APPENDIX 19

USFWS IPaC Screening Documentation

**Reference: Jade Meadow 3 Solar
Project Review Request
Latitude 39.500759, Longitude -79.057904**

RE: "Not Likely to Adversely Affect" determination for the northern long-eared bat (NLEB) for the Jade Meadows III Solar project in Garrett and Allegany Counties, Maryland

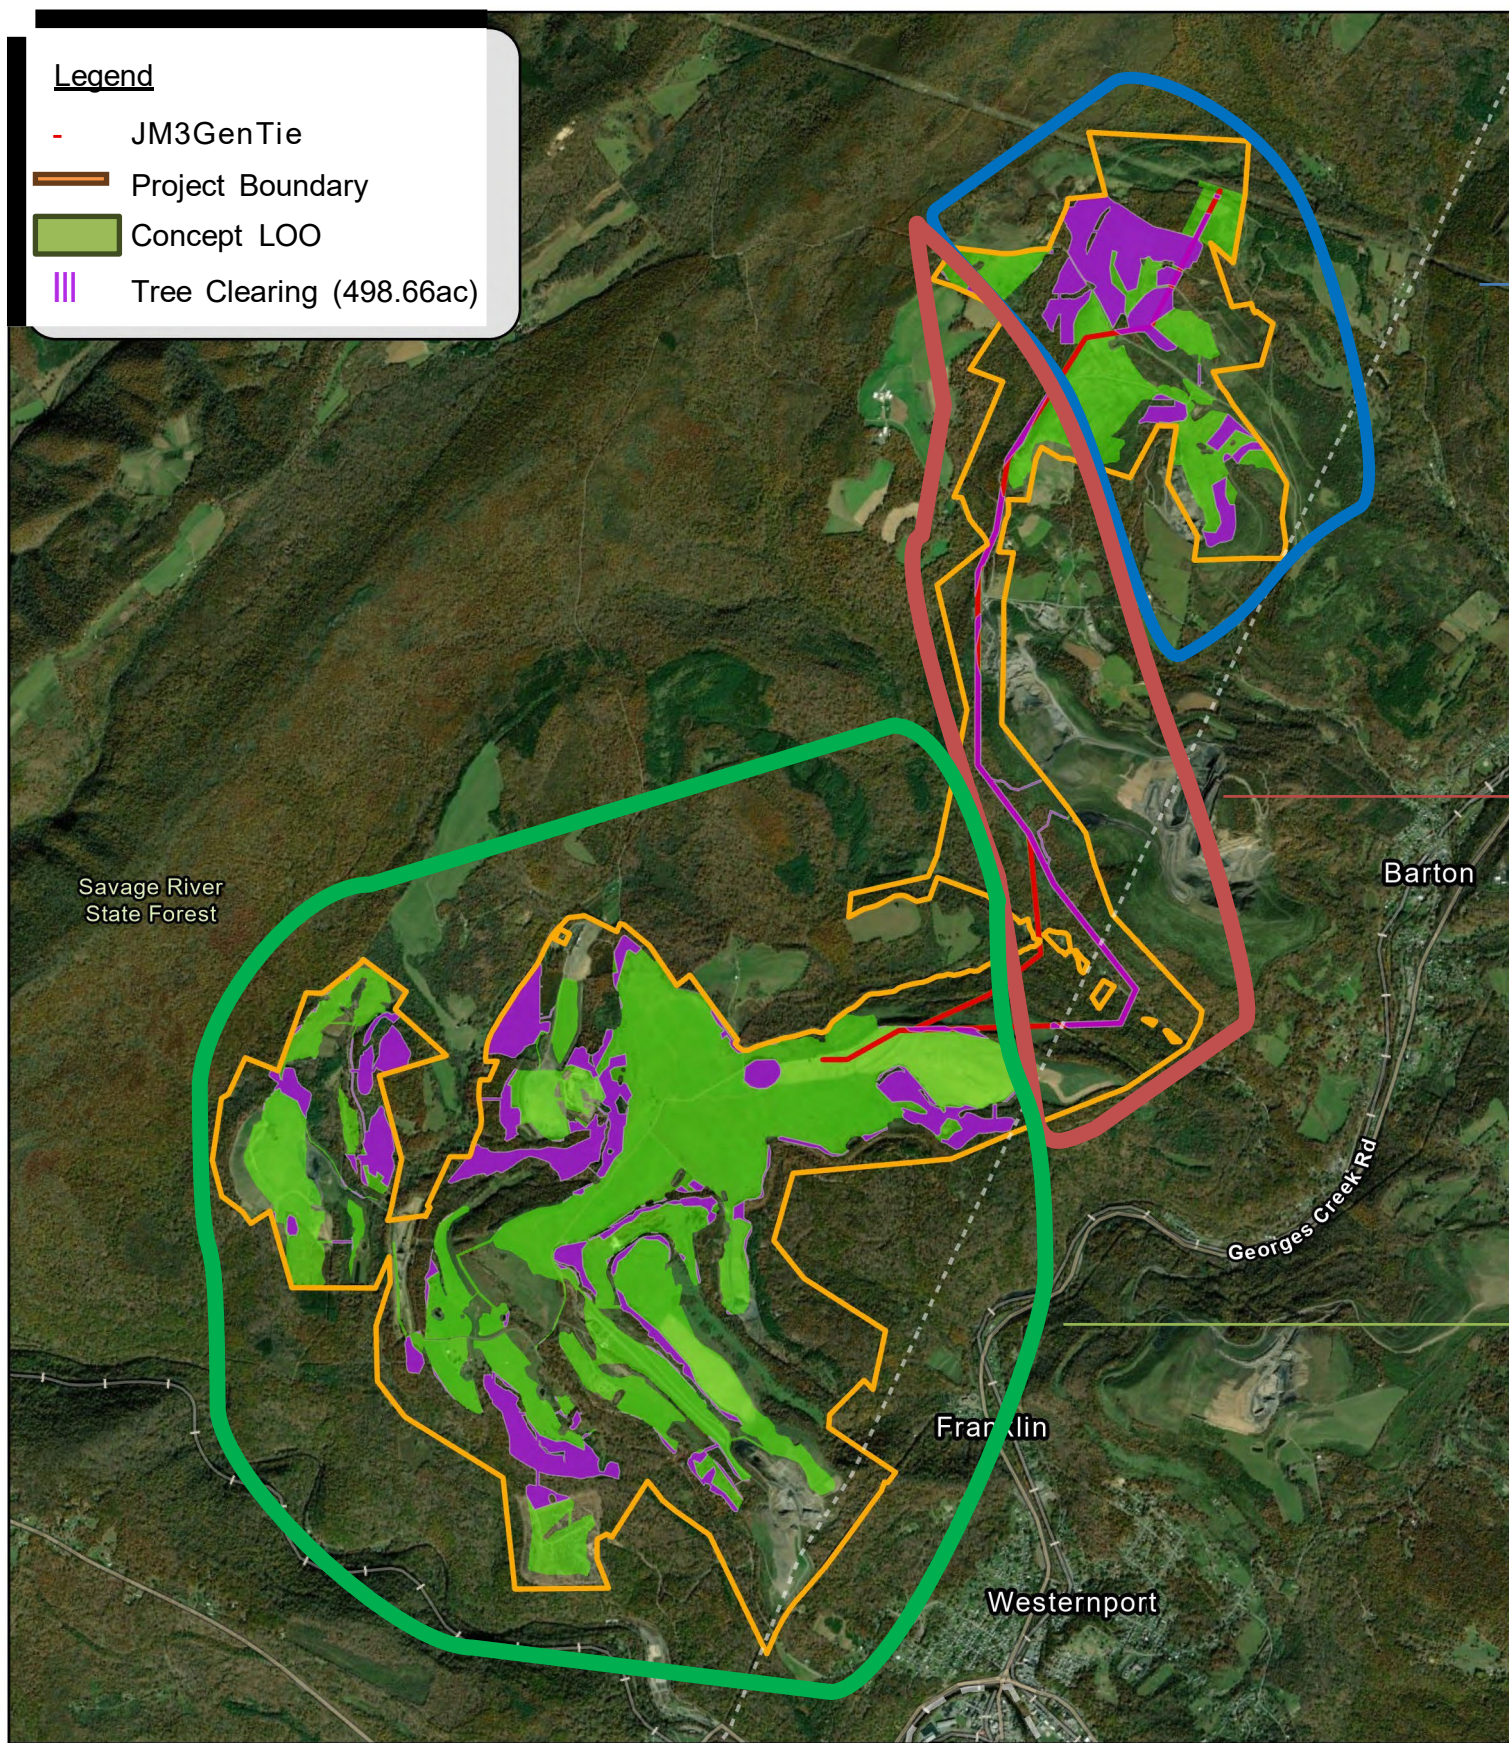
A map of the project area specifying time-of-year restrictions (TOYR) is included with this letter. Given the size of the project area and amount of proposed tree clearing to be conducted, the area was divided into three parcels based on proximity to hibernacula and acoustic detections. Parcel 1 is located within the northernmost part of the project area outside of NLEB hibernacula and acoustic buffers; TOYR on tree clearing activities are from **May 15 to July 31**. Parcel 2 is located within NLEB acoustic buffer areas; TOYR on tree clearing activities are from **April 1 to September 30**. Parcel 3 is located within a NLEB hibernacula buffer; TOYR on tree clearing activities are from **April 1 to July 30** and **October 1 to March 30**. While TOYRs are typically in place for fall swarming within hibernacula buffers from August 16 to November 15, it is unlikely that NLEB will go into torpor (ie. state of mental or physical inactivity due to cold temperatures) from August 1 to September 30 as average temperatures are likely to remain above 40 degrees Fahrenheit. Tree clearing will remove potential summer roost, but additional habitat is present nearby and contiguous with the limits of disturbance.

The northernmost part of the project area is located outside of NLEB hibernacula and NLEB acoustic buffers. TOY restrictions on tree clearing activities within this portion are during NLEB pup season – **May 15 to July 31.**

This portion of the project area is located within NLEB acoustic buffer areas. TOY restrictions on tree clearing activities are during summer occupancy – **April 1 to September 30.**

This portion of the project area is located within the NLEB hibernacula buffer area. TOY restrictions on activities that may cause disturbance near hibernacula (tree clearing, light/noise) would be in place for the active and inactive seasons – **April 1 to July 30; October 1 to March 30.**
